Braidwood Station, Units 1 and 2
Facility Operating License Nos. NPF-72 and NPF-77
NRC Docket Nos. STN 50-456 and STN 50-457

Byron Station, Units 1 and 2
Facility Operating License Nos. NPF-37 and NPF-66
NRC Docket Nos. STN 50-454 and STN 50-455

Subject: Additional Information Supporting the License Amendment Request to Permit
Up-rated Power Operations at Byron and Braidwood Stations

Reactor Vessel Mixing Volume Figures for Hot Leg Switchover Considerations

Figure 1. Illustration of Baffle-Former Regions Considered in HLSO Calculation Mixing Volume

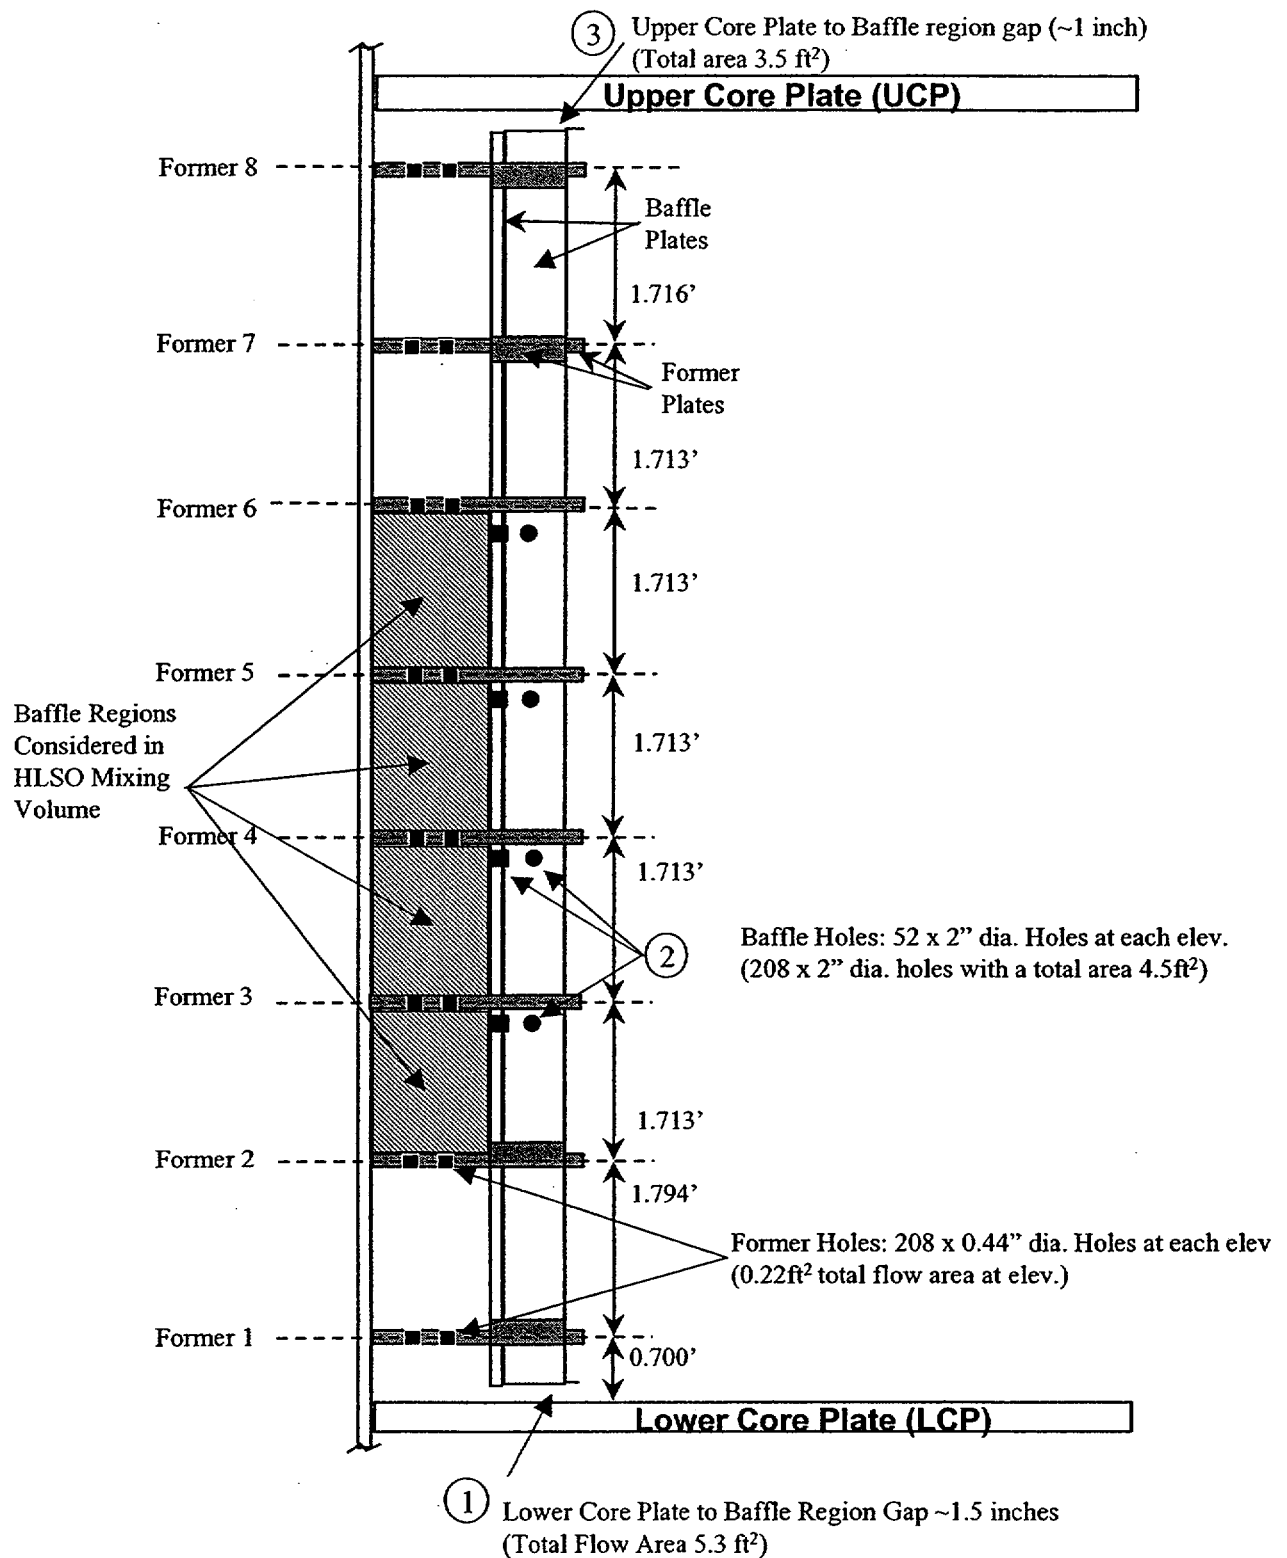
Braidwood Station reactor vessels, which were designed to have upward flow in the barrel-baffle region during normal operation. As shown in Figure 1, plants of this design have three main flow paths between the core and the barrel-baffle region: (1) near the core inlet, through the gap between the lower core plate and the bottom of the baffle plates; (2) at four axial elevations along the active fuel height, through pressure relief holes in the baffle plates; and, (3) near the core outlet, through the gap between the top of the baffle plates and the upper core plate. Axial flow within the barrel-baffle region passes through holes in the former plates, with a steady-state bypass flow through the barrel-baffle region of about 1,600 gpm for Byron Station and Braidwood Station under uprated power conditions.

The reactor vessel mixing volume included only those local regions of the barrel-baffle region between former plates where there are baffle holes that allow for flow communication with the core (i.e., see Attachment 1). The reactor vessel mixing volume included the volume from the top of the lower core plate to the bottom of the active fuel. The inclusion of these volumes is considered acceptable due to mixing of the boron solution driven by flow circulation, fluid agitation from boiling, and diffusion phenomenon in the mixing volume. Flow circulation will be maintained in the mixing volume due to fluid density gradients.
